2925 E Madison St., Seattle WA 98112

A Proposed Apartment Development Project for TVC Madison Co. L.L.C.

EARLY DESIGN GUIDANCE MEETING #2

PROJECT# 3020338

EDG #1 PREFERRED OPTION

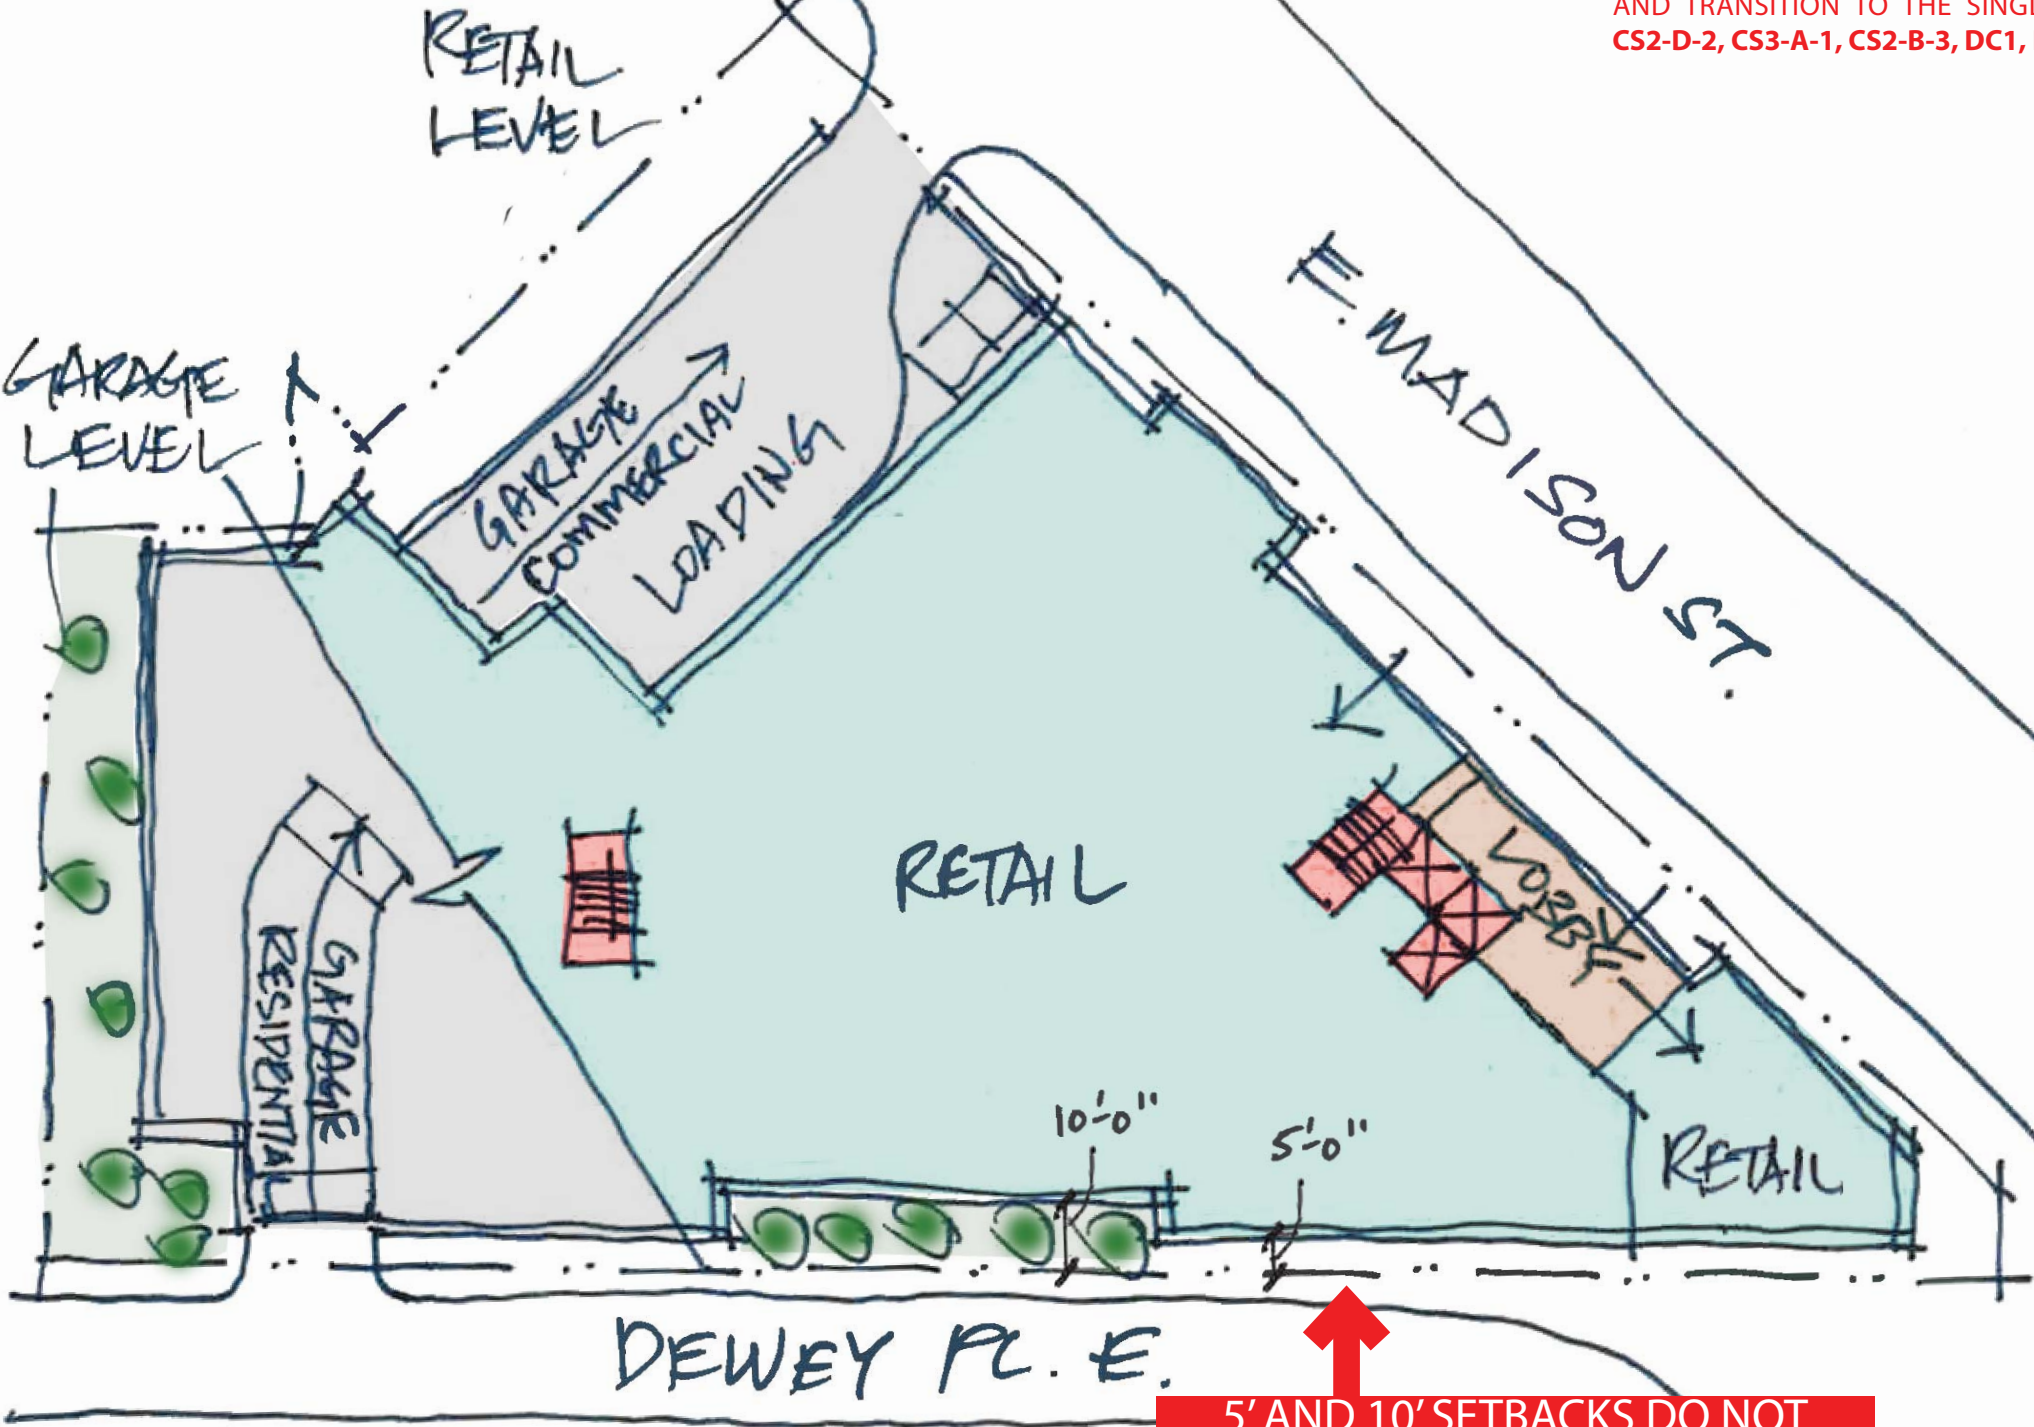
THE BOARD SUGGESTED THAT THE APPLICANT EXPLORE METHODS FOR IMPROVING THE DESIGN RESPONSE TO THE SITE TOPOGRAPHY AND TRANSITION TO THE SINGLE FAMILY ZONING. (CS1-C, CS2-A, CS2-D-2, CS3-A-1, CS2-B-3, DC1, DC3-C-3)

5' AND 10' SETBACKS DO NOT PROVIDE ADEQUATE RESIDENTIAL ZONE TRANSITION

EDG #1
PREFERRED OPTION

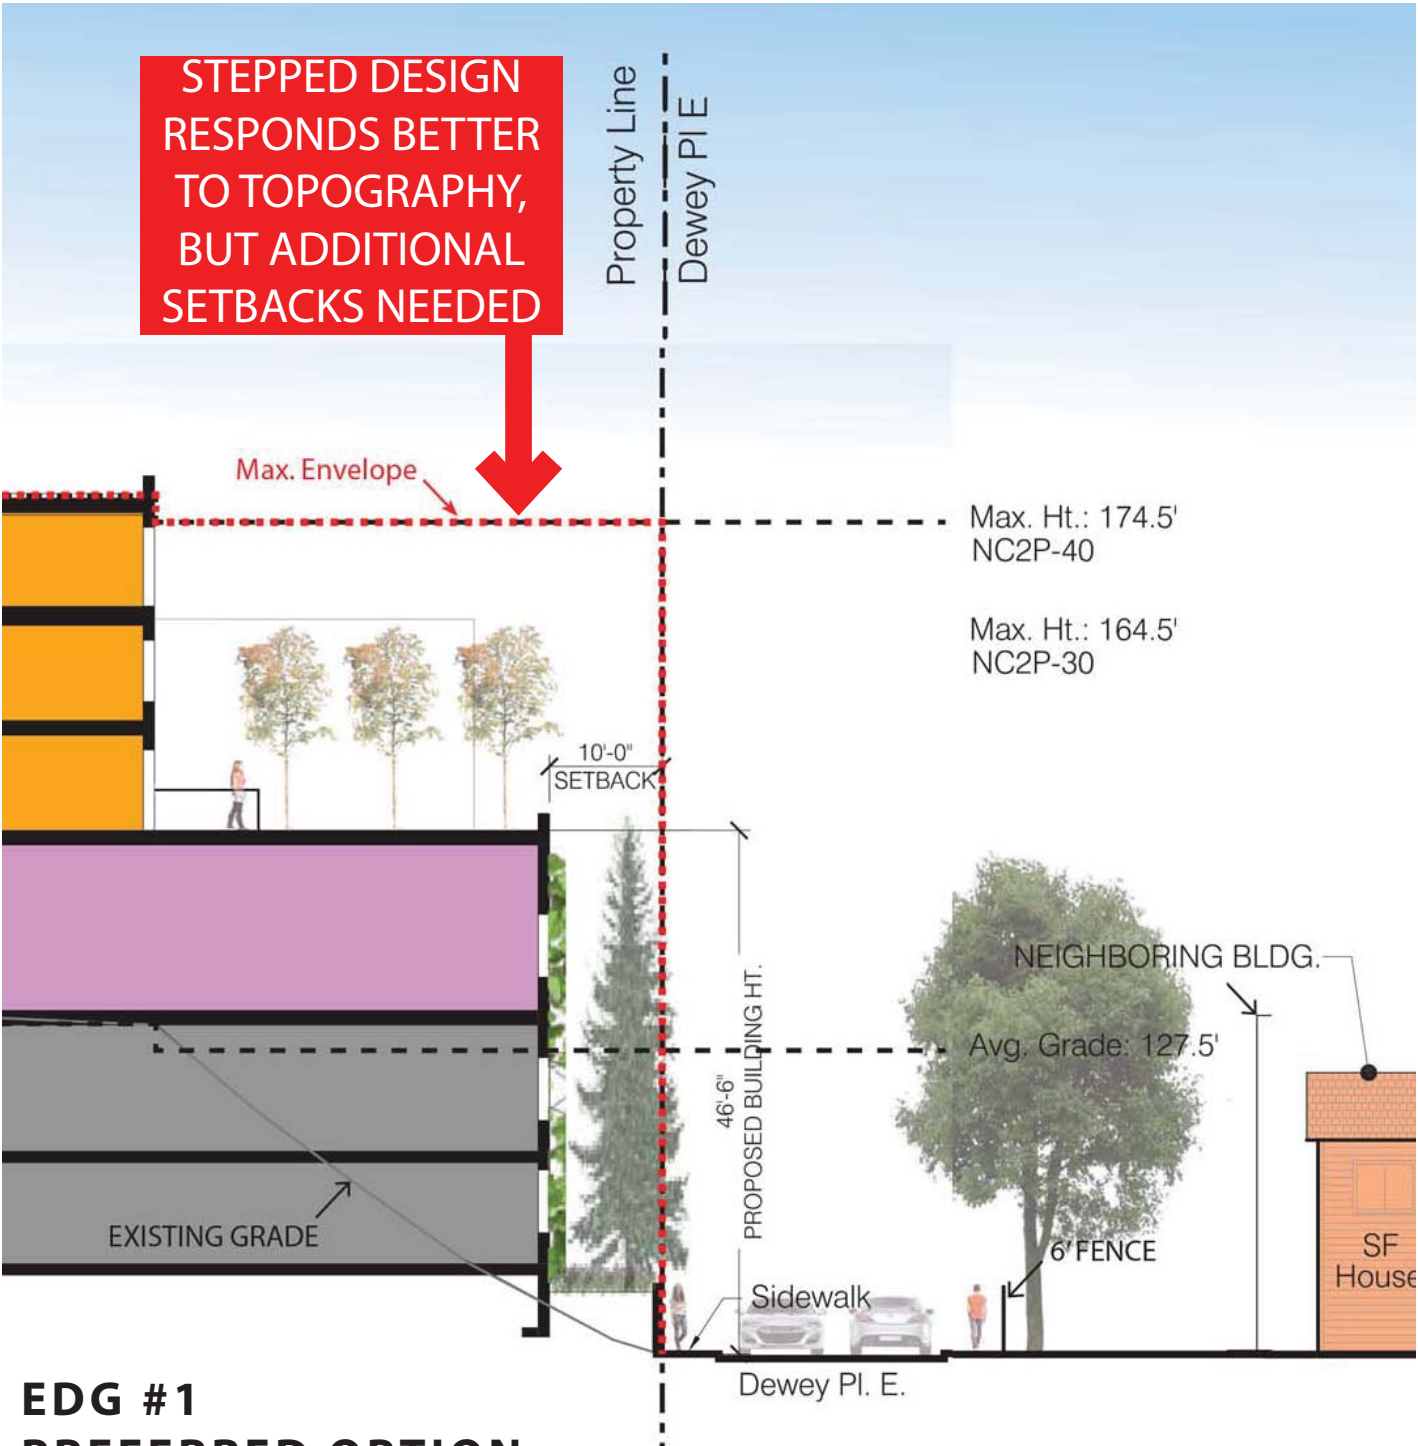
THE BOARD QUESTIONED IF TWO STORIES OF ELEVATED PARKING PROVIDES THE BEST FRONTAGE ALONG DEWEY AND THE ADJACENT SINGLE FAMILY ZONE. THE BOARD DISCUSSED THE VISIBILITY OF CONCRETE AND GABION BASKETS AND RECOMMENDED DEVELOPING A SENSITIVE SOLUTION USING HIGH QUALITY MATERIALS WHICH BETTER RELATE TO THE SURROUNDING RESIDENTIAL CONTEXT. (CS1-C, CS1-D, CS2-A, CS2-B, CS2-D, DC2-A, DC3-C-3)

STEPPED DESIGN WITH INCREASED SETBACKS DIRECTLY RESPONDS TO SITE TOPOGRAPHY

HEIGHT CALCULATION

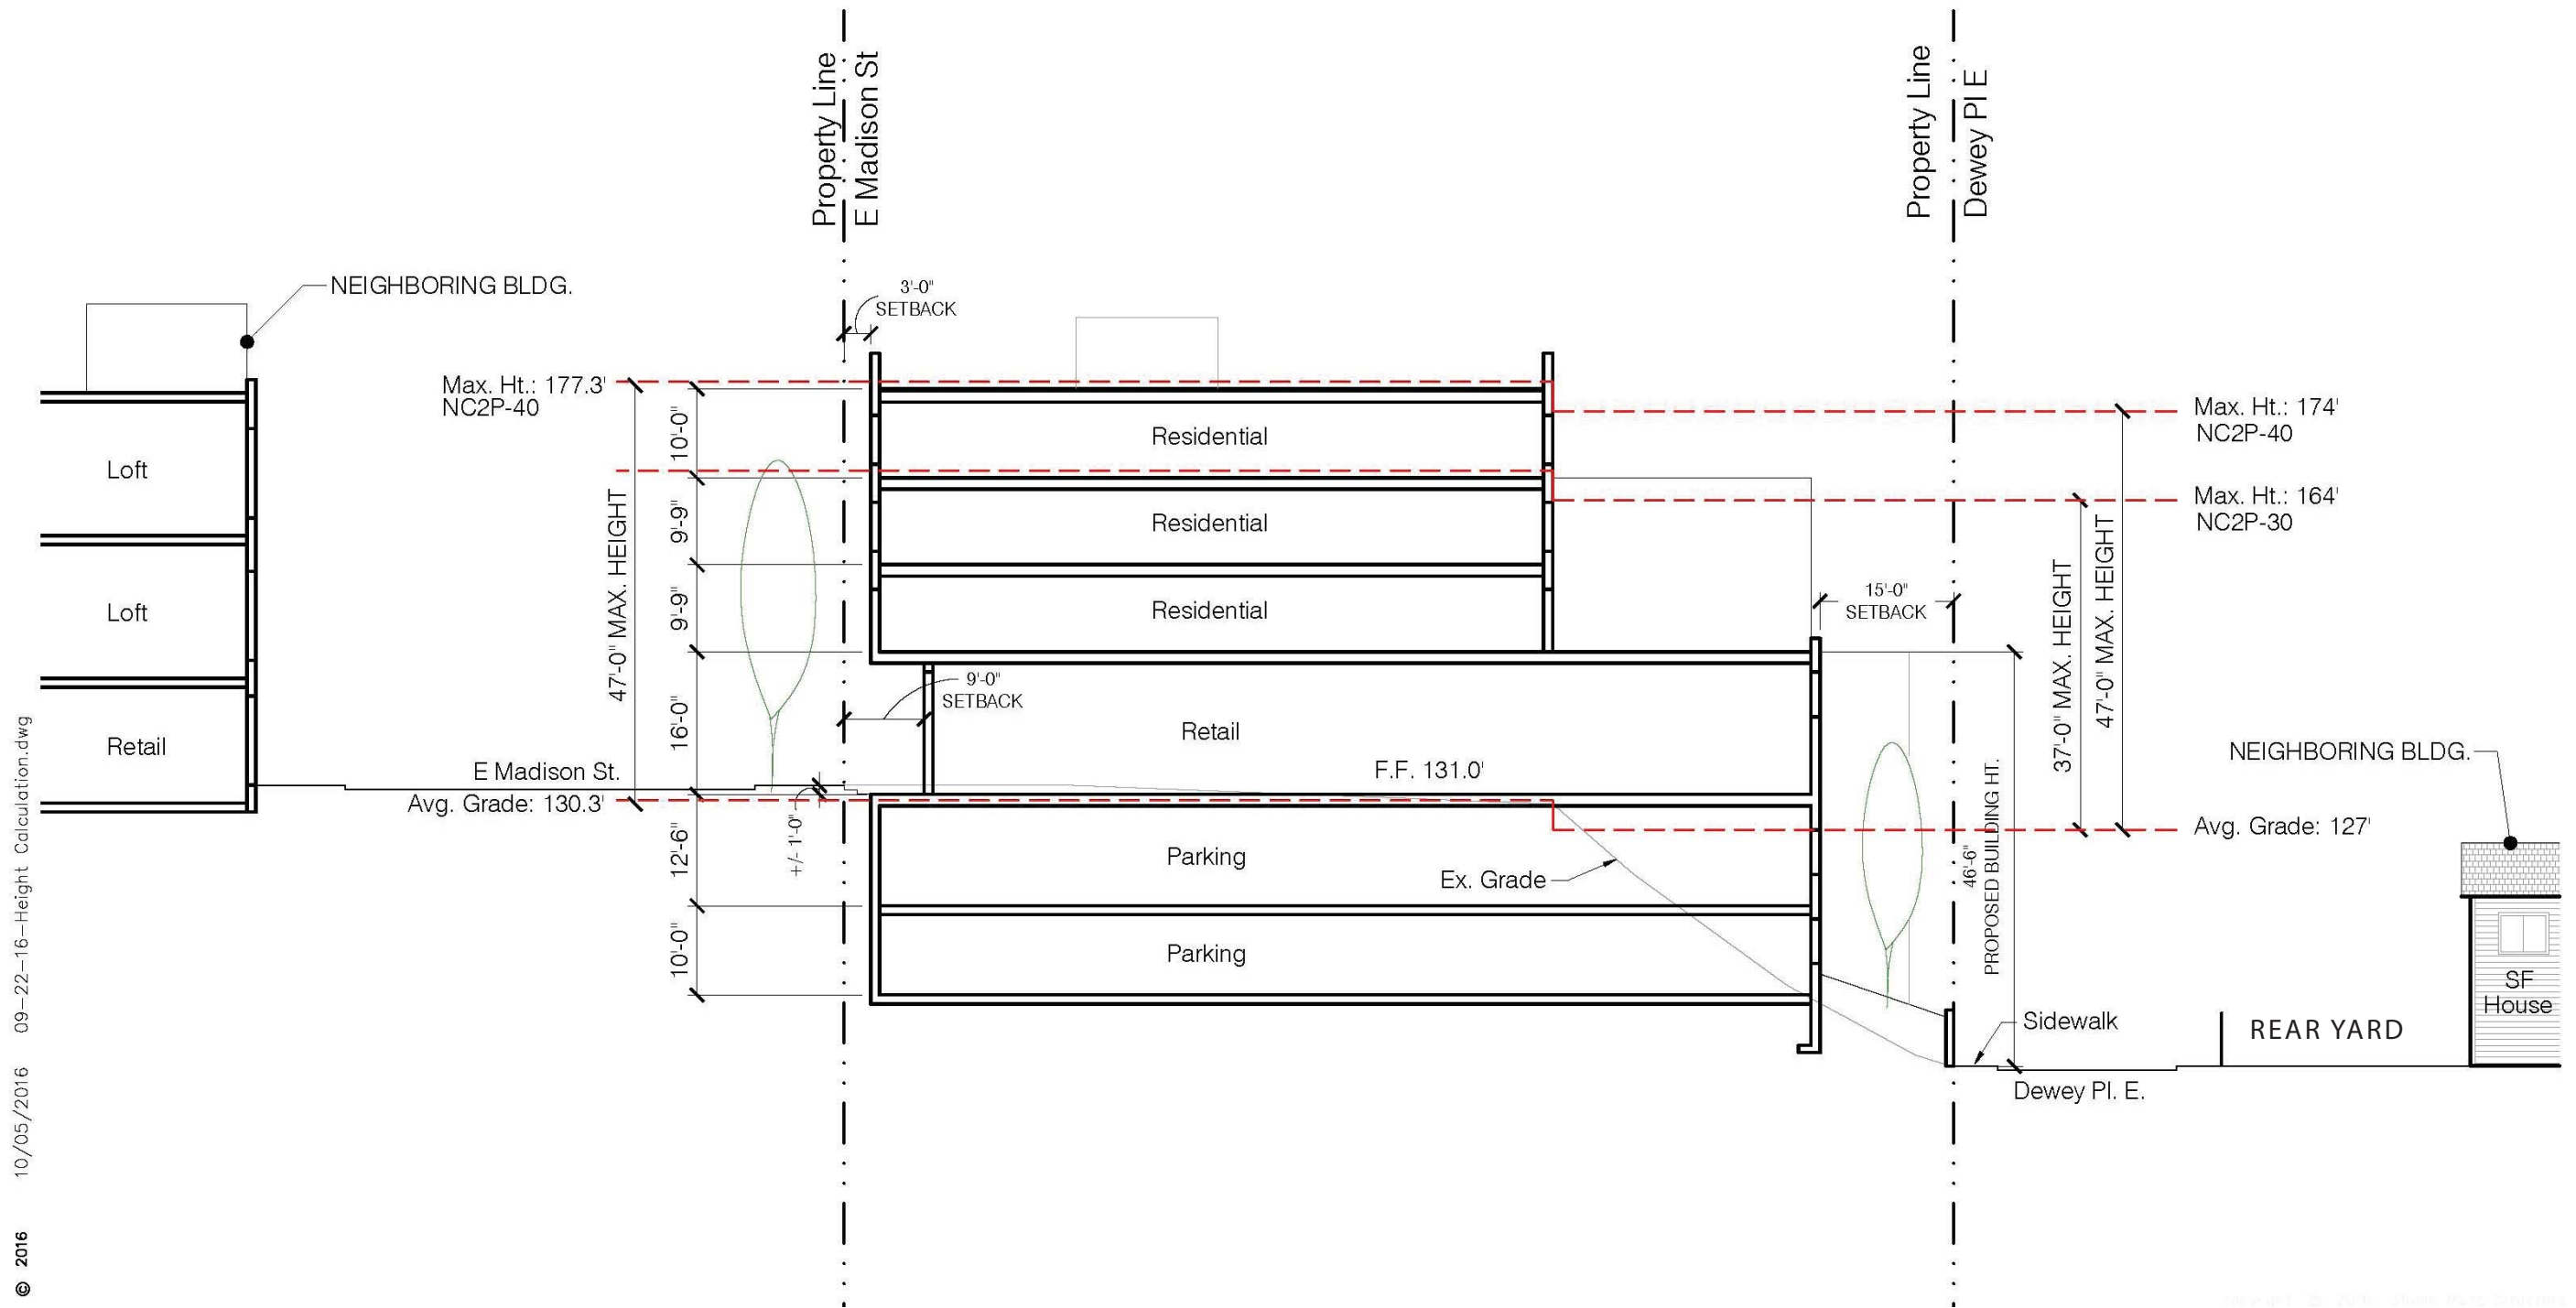
- b. In order to address concerns about how the building height is calculated, the Board requested more information and if possible, verification that the calculation is code compliant for the next meeting. (CS1-C-2, CS2-D, DC2-A-1)
The allowable building height calculation has been vetted with a SDCI zoning reviewer. (See Height Calculation)

Average Grade Level Calculation
The Average Grade Level was calculated using SMC 23.86.006.A.2. Per DPD Director's Rule 4-2012 Height Measurement: Calculating Average Grade Level - Option to the General Rule, "Subsection 23.86.006.A.2 provides an acceptable option for determining average grade level to allow structures to better respond to the topography of sloping sites." The code section is referenced below along with applicant's corresponding methods.

Section 1: $\frac{(A1 \times a) + (A2 \times a)}{a + a} = \frac{(131.8 \times 152.5) + (128.9 \times 152.5)}{152.5 + 152.5} = \frac{20,053.75 + 19,565.75}{305} = 130.3$

Section 2: $\frac{(B1 \times b) + (B2 \times b)}{b + b} = \frac{(132.1 \times 40) + (121.9 \times 40)}{40 + 40} = \frac{5,284 + 4,876}{80} = 127$

EDG #1
PREFERRED OPTION
NORTHEAST SECTION

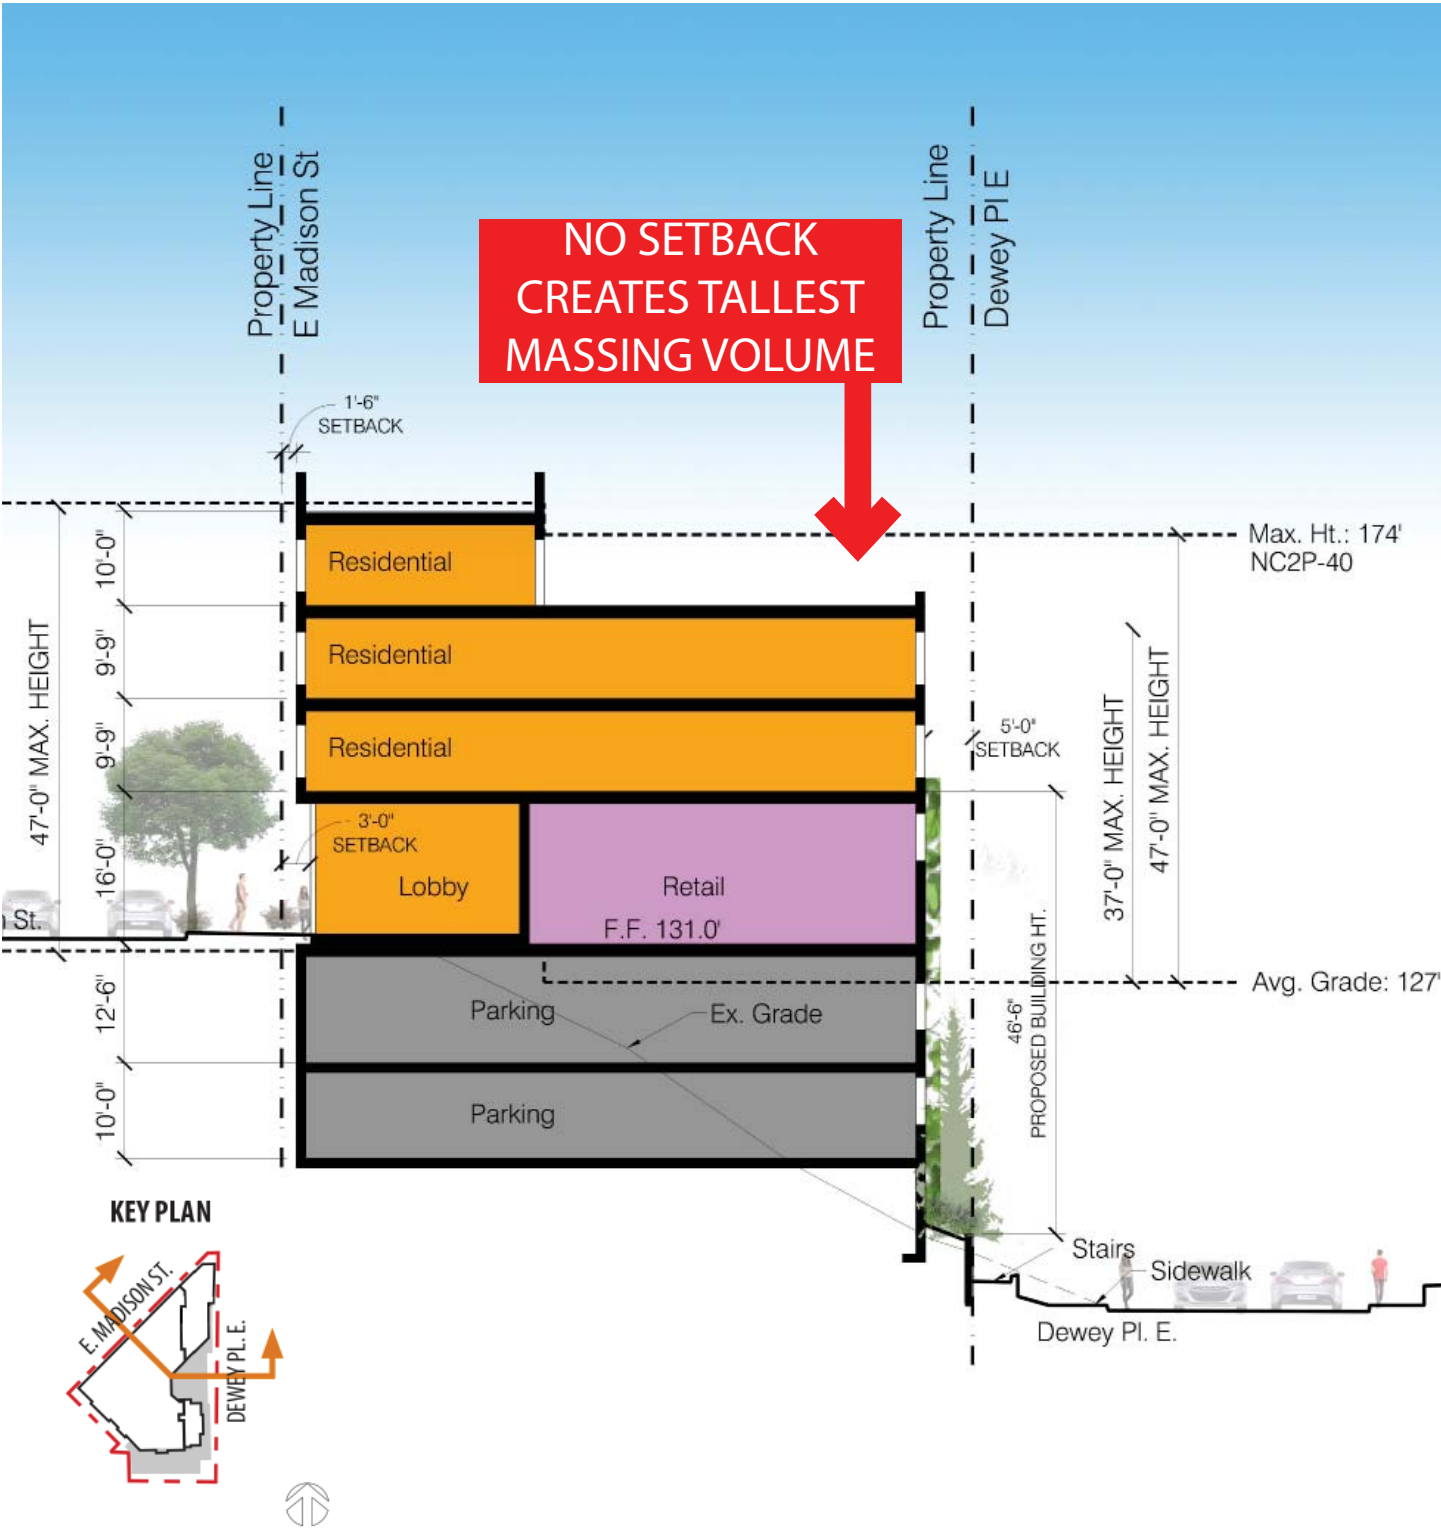
THE BOARD NOTED THAT THE TALLEST MASSING VOLUME APPEARS TO BE AT THE NORTHEAST CORNER AND AGREED THIS AREA WILL BE HIGHLY VISIBLE AND THE SCALE RELATIONSHIP IS CRITICAL. (CS2-A, CS2-B, CS2-C1, CS2-D, DC2-A-2, DC2-B, DC2-D-1)
